Tesla, Inc. Service Bulletin		<h2 style="margin: 0;">Inspect Restraint Control Module Configuration</h2>	
SB-22-20-002 April 22, 2022			
Classification		Section/Group	Mobile Service
Recall Bulletin		20 - Safety and Restraint	Can Perform (where permitted)
Model Year	Model	Country/Region	Build Location
2022	Model 3	Europe	Giga Shanghai
<small>The model(s) and model year(s) listed are a general approximation of the affected VIN list. Refer to the VIN/Bulletin Tracker or Customer/Vehicle profile to determine applicability of this bulletin for a particular vehicle.</small>

Figure 1

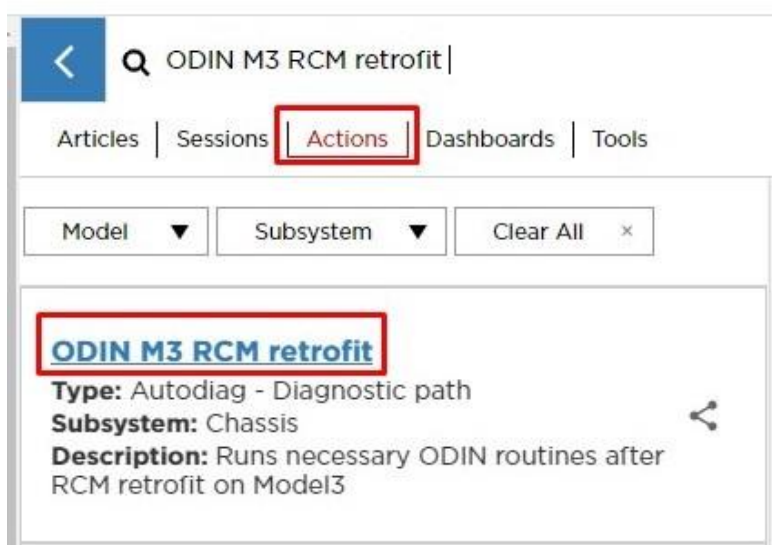
1. Connect a laptop with Toolbox 3 to the vehicle.
2. Select the **Actions** tab, and then search for "ODIN_M3_RCM_retrofit" (Figure 1).

Figure 2

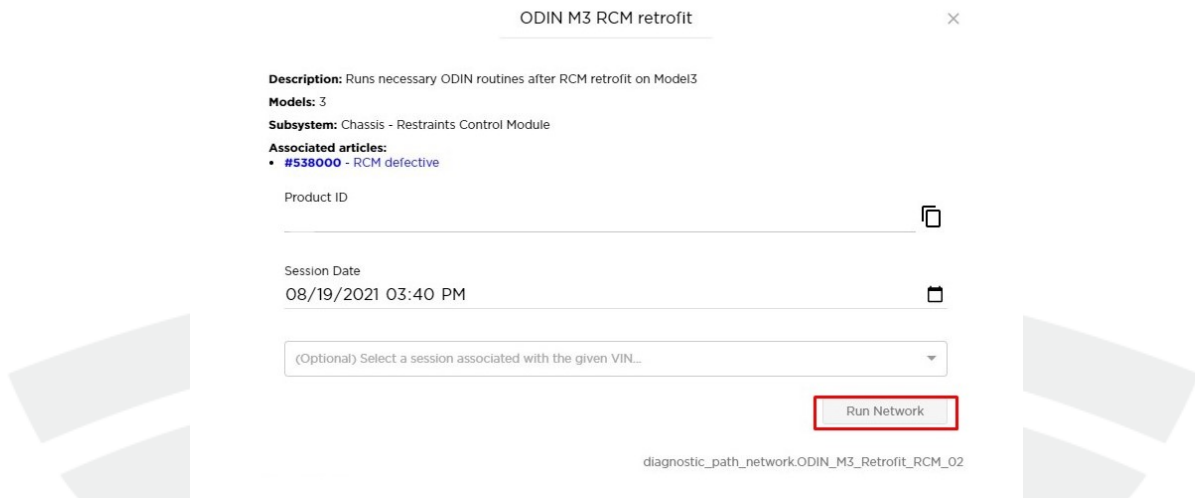
3. Select **ODIN M3 RCM retrofit**, and then click **Run Network** (Figure 2). Allow the routine to complete before continuing.
